Office Action Summary	Application No. 10/589,317	Applicant(s) MOSER ET AL.	
	Examiner ROBERT E. FULLER	Art Unit 3676

DETAILED ACTION

Figure 1 - Huber as it relates to the claimed invention.

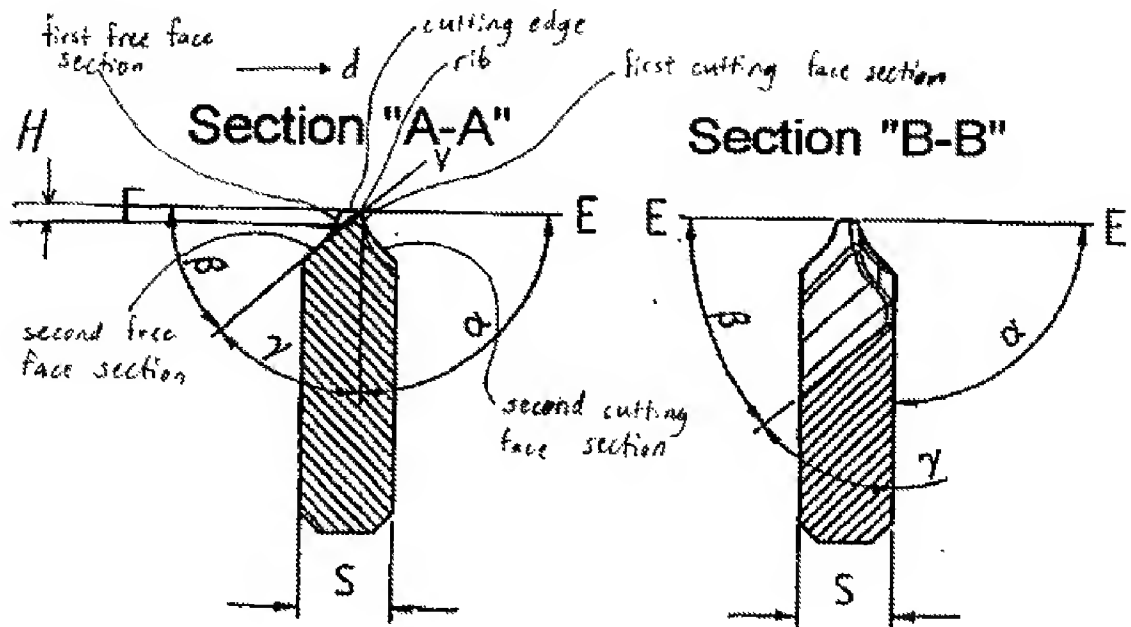
With regard to claim 1, Huber discloses a drilling tool (1), especially for percussion drilling, which comprises a cutting element (2) that is configured as a plate or head and that has at least one cutting edge (3) defined by a cutting face (5) and a free face (7), wherein the cutting edge is associated with a first free face section (see Figure 1 below) which lies in a cutting plane and is limited by a convex bulge or a convex polygon outline (see Figure 1 below), and wherein the vertical height of a rib (see Figure 1 below) defined by the first free face section and an associated first cutting face section appears to range from .1 mm to 1.0 mm. Note that, with respect to the above rejection under 35 U.S.C. 112, the claims are being examined as best understood by the examiner.

With regard to claim 5, a second free face section follows the first free face section (see Exhibit A).

With regard to claim 6, Huber discloses a second free face section (see Exhibit A).

With regard to claim 7, an extension (see "V" in Exhibit A) extends in a direction of rotation (see "d" in Exhibit A) of the drilling tool through the cutting element below the cutting edge.

8. Applicant's arguments filed November 13, 2008 have been fully considered but they are not persuasive. Applicant has argued that Huber discloses a chisel face and a rake face, rather than a cutting face and a free face, respectively. Examiner respectfully traverses this argument, since the claims do not describe the cutting face and the free face well enough to preclude Huber from reading on them. All the claim requires is a cutting edge, a cutting face, and a free face. Almost any drill bit cutting plate comprises these structural elements, since a plate necessarily has a cutting edge that must be bound by two faces on either side of it. Whether Huber calls these faces "chisel faces" or "rake faces" is immaterial. Figure 3 of Huber shows a top view of the cutting plate. According to examiner's understanding, to the left of plane A-A, the portion above the cutting edge (4) can broadly be considered a "free face" and what is below the cutting edge (4) can broadly be considered a "cutting face."

Figure 2 - Dunn et al. as it relates to the claimed invention.

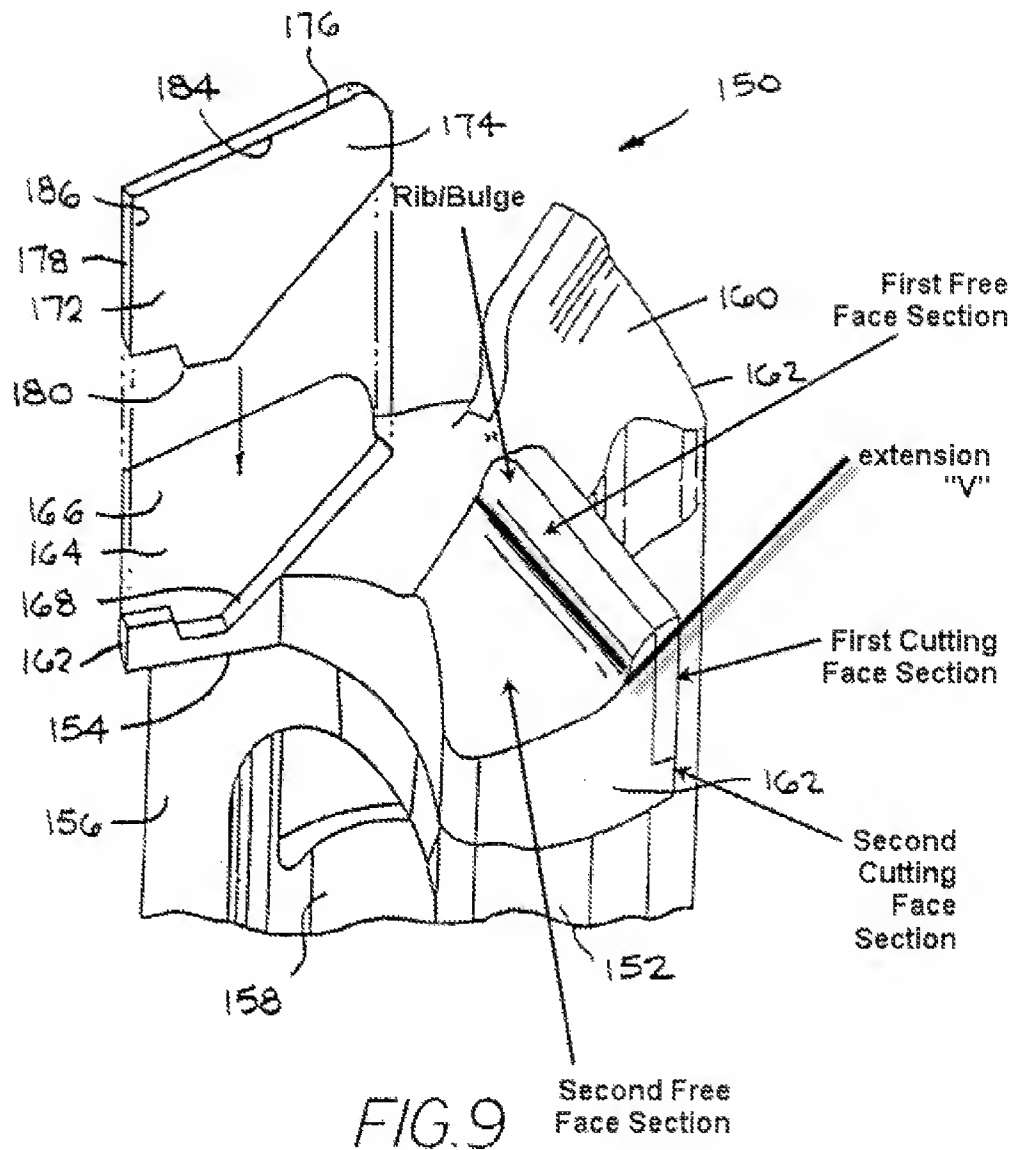
With regard to claim 1, Dunn discloses a drilling tool (150) for percussion drilling, which comprises a cutting element (162) that is configured as a plate or head and that has at least one cutting edge (184) defined by a cutting face (174) and a free face (160), wherein the cutting edge is associated with a first free face section (see Figure 1 below) which lies in a cutting plane, wherein the cutting plane (CP) is cut at a right angle to the cutting edge and is limited by a convex bulge (see Figure 2 below) or a convex polygon outline, and wherein the vertical height (H) of a rib (see Figure 2 below) defined by the first free face section and an associated first cutting face section (see Figure 2 below) ranges from 0.1 mm to 1.0 mm.

With regard to the ranges in both claims 1 and 2, the size of the rib falls within the claimed range, as the rib is only defined by a first free face section and an associated first cutting face section, and examiner can assign where the first free face begins in Dunn. Therefore, the first free face begins 0.5 mm below the cutting edge.

With regard to claims 5 and 6, Dunn discloses a second free face section and a second cutting face section (see Figure 2 below).

With regard to claim 7, an extension (see "V" in Figure 2 below) of the second free face section extends in a direction of rotation of the drilling tool through the cutting element below the cutting edge.
